Program Manager
Office of Renewable Energy
Bureau of Ocean Energy Management
45600 Woodland Road
Sterling, Virginia 20166

RE: Public Comments on Ocean Wind Draft Environmental Impact Statement (DEIS) Docket BOEM-2022-0021

Detailed comments

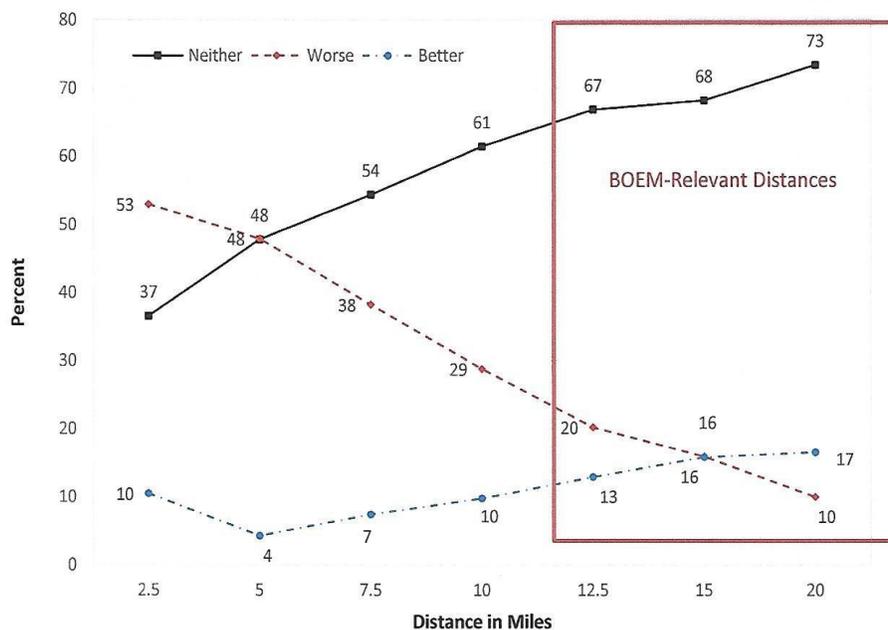
3 Visual impacts of turbines in the Proposed Project on Tourism should be considered “major” instead of “moderate”, and a new study is needed to determine potential economic costs. No Final EIS should be issued for any project until that study is available.

BOEM states under the topic Recreation and Tourism on 3.18 - 22, “Overall, the impacts of the Proposed Action are anticipated to be moderate and minor beneficial”. The turbines will be 15 miles off Atlantic City, are 906’ tall, and will be “theoretically visible to a viewer at the ocean surface or at beach elevations at distances up to 39.6 miles with clear-day conditions”. BOEM quotes a University of Delaware study, 3.18-8, “evaluating the impacts of visible offshore WTGs on beach use found that WTGs visible more than 15 miles from the viewer would have negligible impacts on businesses dependent on recreation and tourism activity (Parsons and Firestone 2018). The study participants viewed visual simulations of WTGs in clear, hazy, and nighttime conditions (without ADLS)”. Below is a copy of the chart quoted from the UD study.

However, even with the studies problems it has some use. The figure below shows at 10 miles 29% found the view worse while only 10% found it better for a 19% difference choosing worse. At 7 miles 38% found the view worse compared to 7% favorable, a 31% difference. In looking at the cumulative impacts of immediately adjacent planned offshore wind projects Ocean Wind 2 is only 8.9 miles from the beach, Atlantic Shores South is 8.8 miles, and Atlantic Shores North is 9.1 miles. So ignoring the taller towers in the Ocean Wind 1 project we see perhaps 25% of tourists will find the cumulative impact worse. The impact of taller towers can be approximated by assuming the towers are 1.56 times closer (the ratio of 579' tall towers to 906' tall towers). That suggests the adjacent projects will have the impacts of turbines 5 miles off the coast in the UD study, and the proposed Ocean Wind project would be equivalent to about 10 miles off the coast. The proposed project then should be considered to have a major impact on tourism.

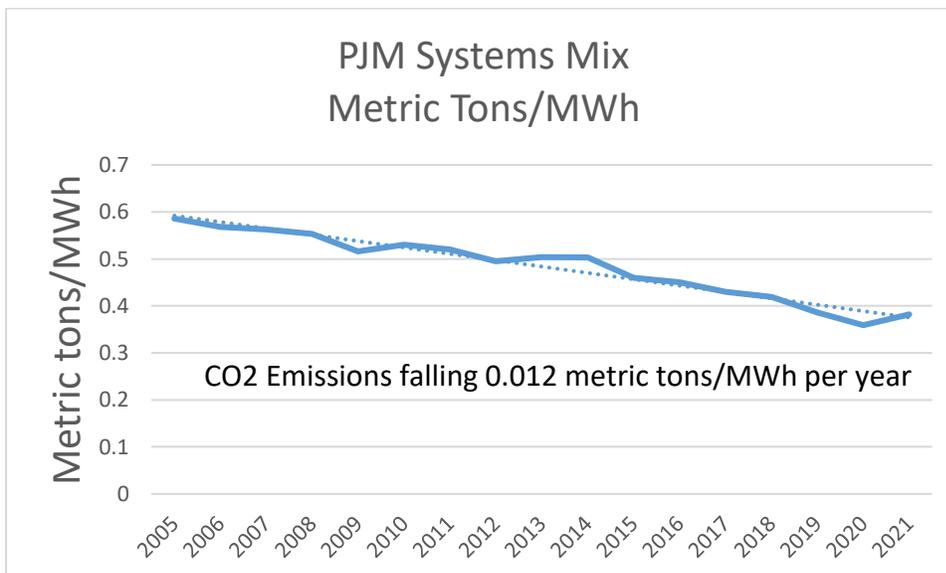
One study published in the journal of the Acoustical Society, “How could operational underwater sound from future offshore wind turbines impact marine life?”⁶ suggests levels as high 177 to 177 decibels at a 10 MW direct drive turbine. Using the National Oceanic Atmospheric Administration criterion for behavioral disruption for continuous noise (i.e., level B at 120 decibels), a single 10 MW direct drive turbine is expected to cause behavioral response in marine mammals up to 1.4 km (0.85 miles) distance from the turbine. As the turbines will spaced on a 1 by 1.2 mile grid the Level B threshold will likely be exceeded everywhere in the project area resulting in this having a major impact. The critically endangered North Atlantic right whale commonly seen in the project area would be severely impacted by noise harassment and there is no obvious mitigating action to protect the whale.

Gamesa offers a 10 MW direct drive turbine for sale but none have been installed yet. Until actual acoustical testing is completed on such a turbine no offshore wind project should be approved.
